CITY PLAN COMMISSION

FILE NUMBER: S223-128 CHIEF PLANNER: Mohammad H. Bordbar

REQUEST: An application to replat an 18.092-acre tract of land containing all of Lot 1A in City Block A/7558 to create one 0.4302-acre lot and one 17.662-acre lot on property located on Hampton Road, South of Lyndon B. Johnson Freeway / Interstate Highway No. 20.

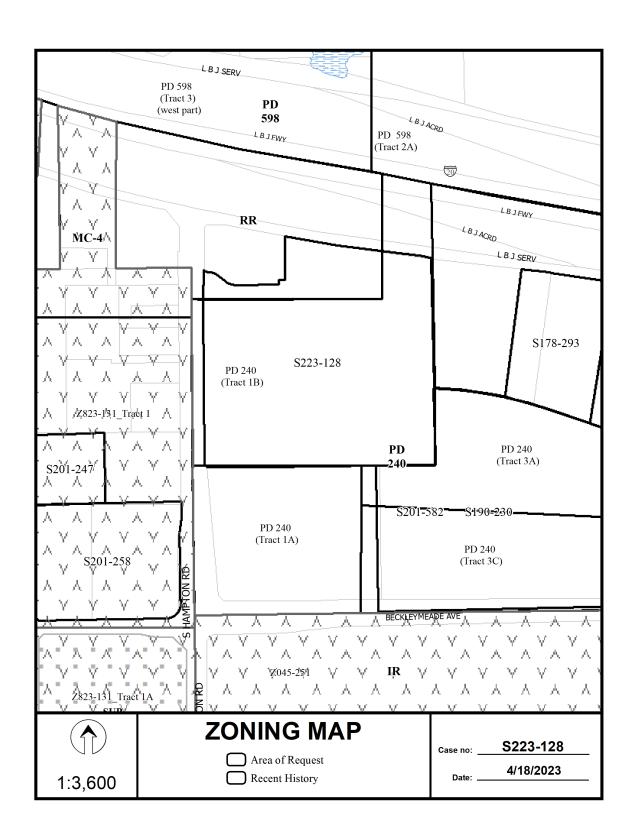
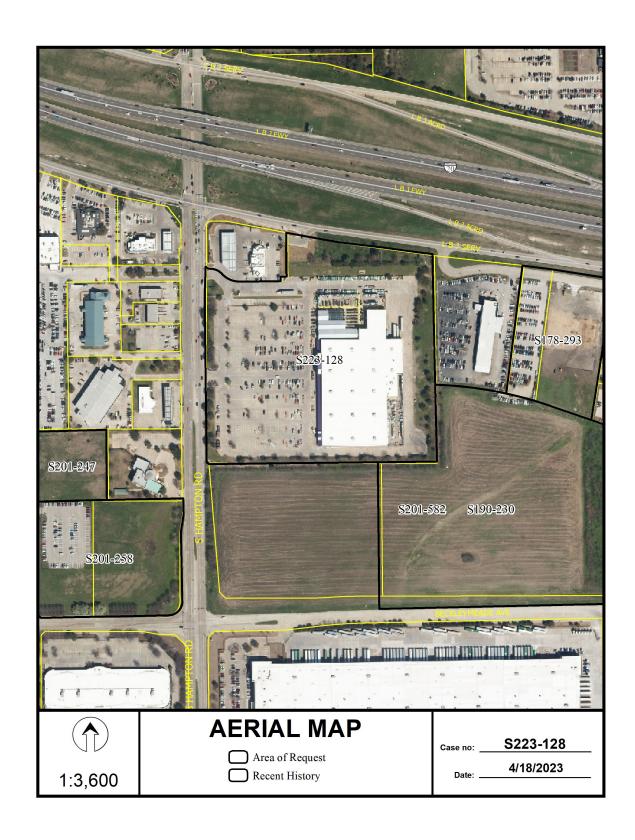
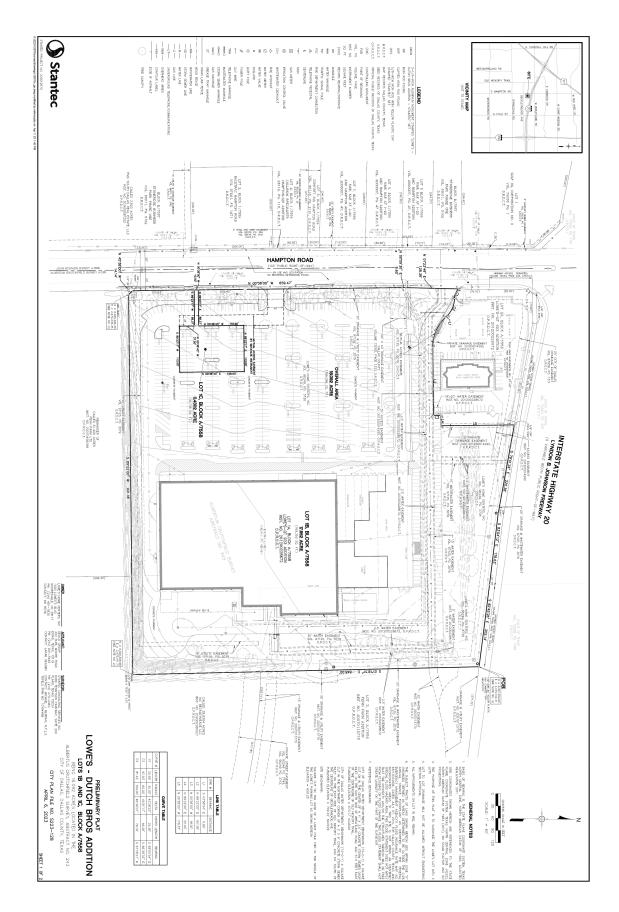
- 24. On the final plat, change "Interstate Highway 20 Lyndon B. Johnson Freeway" to "Lyndon B. Johnson Freeway / Interstate Highway No. 20" Section 51A-8.403(a)(1)(A)(xii)
- 25. On the final plat, identify the property as Lots 1B and 1C in City Block A/7558. Ordinance 1A, Page 131 pages 131-148, Section 2 (passed August 13, 1872).
